Subject: **Docket Nos. 50-361 and 50-362**
Response to Request for Additional Information Regarding
Proposed Technical Specification Change Number 454
San Onofre Nuclear Generating Station Units 2 and 3

**SAN ONOFRE NUCLEAR GENERATING STATION
UNITS 2 AND 3 (SONGS 2 & 3)
RESPONSES TO NRC REQUEST
FOR ADDITIONAL INFORMATION
ON PCN-454**

CALCULATION E4C-082

FIGURE 1
PSS/E & TEST VOLTAGE PROFILES FOR 2A04

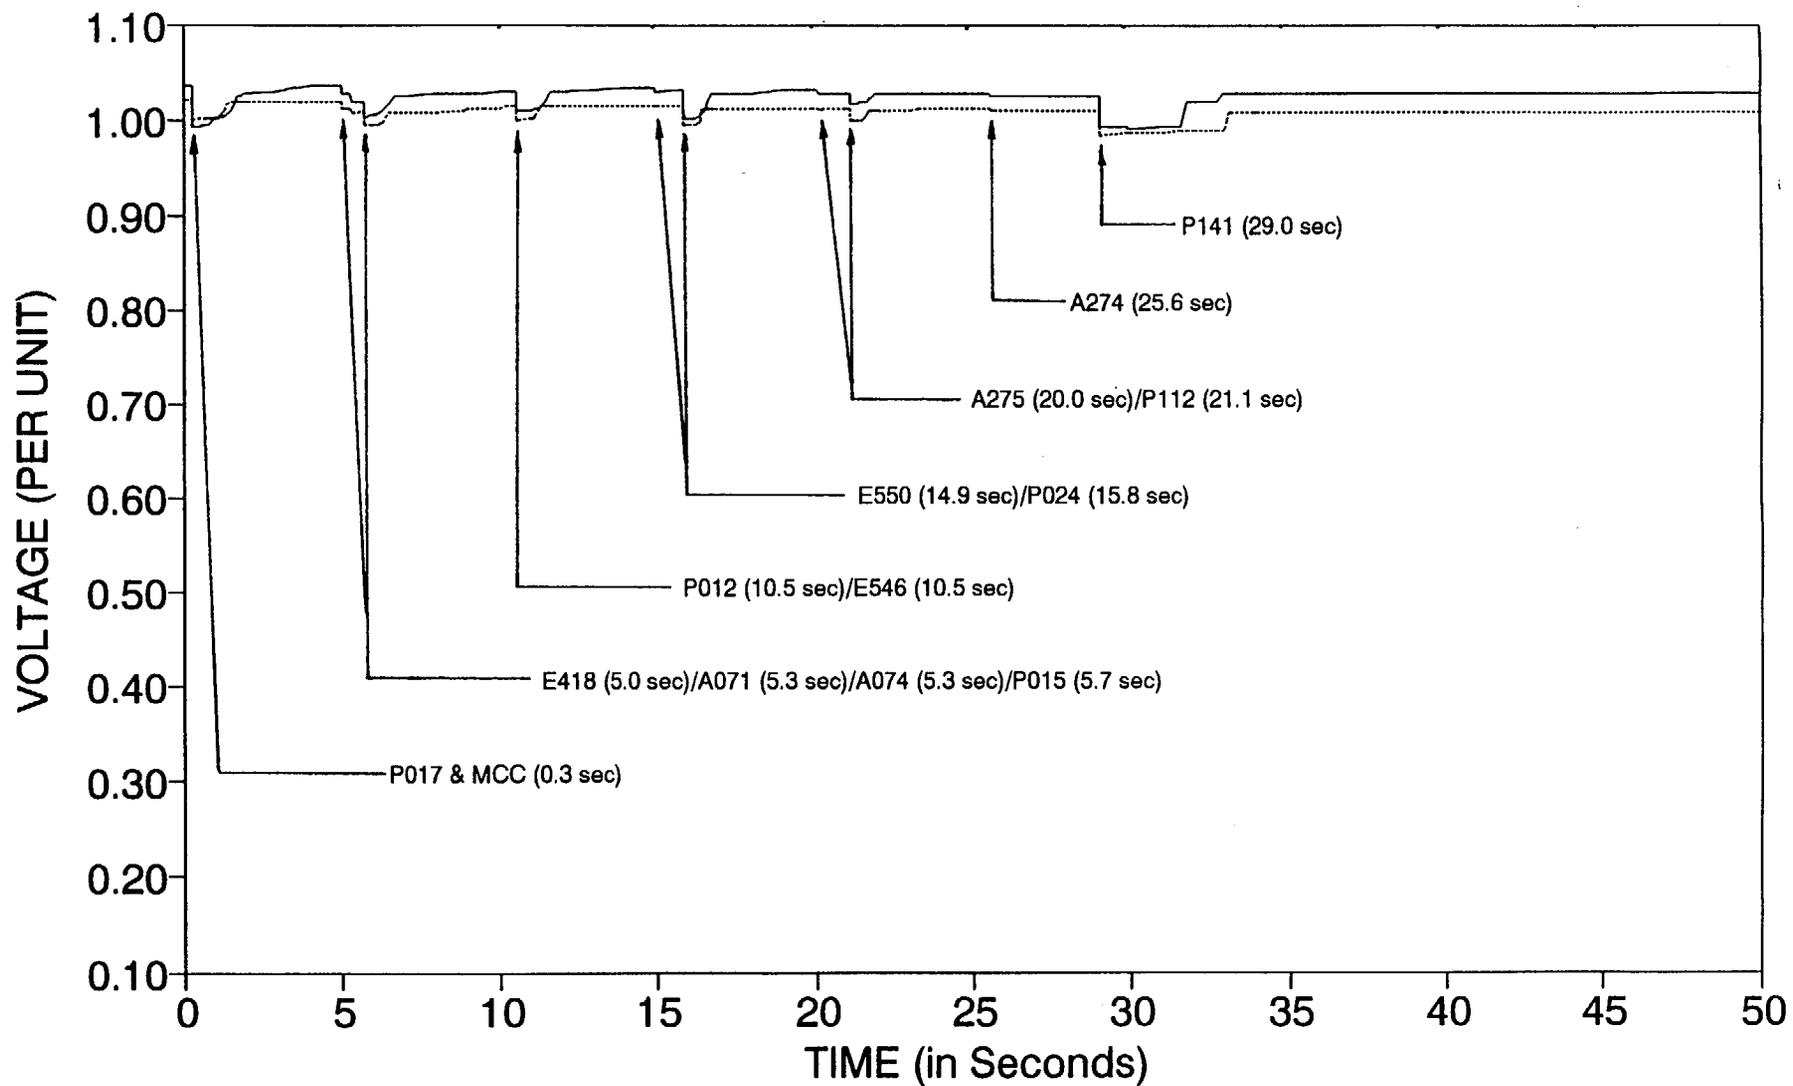
Software Modeling Verification (Enclosure 1, Page 11 of 15) - You stated that analytical techniques and assumptions used in voltage analyses were verified against actual measurements. Please provide details (i.e., minimum voltage at the motor terminals, steady state voltage, acceleration time, and so forth).

PSS/E Program verification was accomplished by simulating a portion of the pre-operational Transformer Voltage Tap Verification test for SONGS Unit 2, and comparing the results of the test with the results of the PSS/E Program simulations. During this test, the dynamic and steady state voltages at the ESF 4.16 KV buses were monitored by a recorder. In the PSS/E dynamic simulation, system loads were adjusted to match the actual test conditions. Each ESF load was then simulated to start at the same time it was started in the actual test. The voltage profiles resulting from the dynamic simulations were then compared with the voltage profiles from the actual test. The resulting plots from the dynamic simulations and actual test were then superimposed for comparison (Figures 1 and 2 of the Attachment to this response document). The steady state voltages from the test and PSS/E verification are tabulated below for comparison.

BUS NO.	TEST RESULTS	PSS/E RESULTS
2A04	4.27 KV	4.1966 KV
2A06	4.24 KV	4.1887 KV

During the test, motor terminal voltages were not measured. Motor acceleration times can be verified by inspection of the voltage profiles.
